INITIAL FIRE SAFETY INSPECTION REPORT

APPARELS VILLAGE LTD(SHIRTS)-NEW BUILDING 2

RSC ID: 24845

Date: 02 January 2024

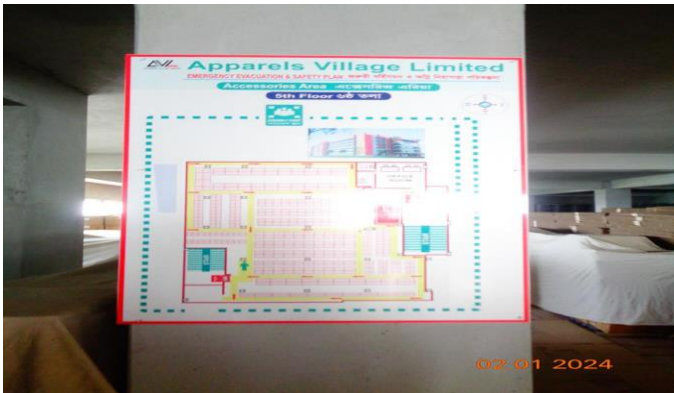
F-3	Fire Rated Construction	Unsealed penetrations and openings are located in the fire rated floor/ceiling assemblies due to Electric cable shaft. Location: Building-8	Seal all penetrations and openings in floor/ceiling (full thickness of the floor/ceiling) assemblies by fire rated materials to maintain the fire resistance rating. or, Provide a minimum 3-hr fire rated shaft to separate the BBT shaft & toilet area from each floor.	Within 3 Months
-----	-------------------------	---	--	-----------------
